**[Updated] PCN # ESW490-49 – Schottky Barrier Rectifier DSTxxx TO-277B Packing Product Reel Change**

Littelfuse would like to notify you that we will replace Carboard reel with ESD plastic reel for Schottky Barrier Rectifier DSTxxx TO-277B packing Products.

**1.0 Physical Difference:**

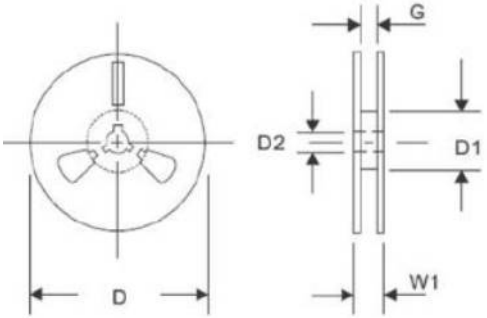
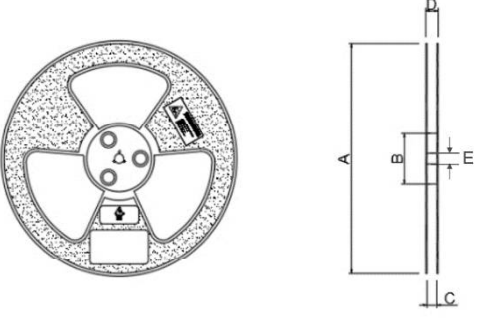
| Type       | Current   | New  |
|------------|---|--|
| Material   | Carboard  | PS   |
| Color      | White Reel  | Bule Reel  |
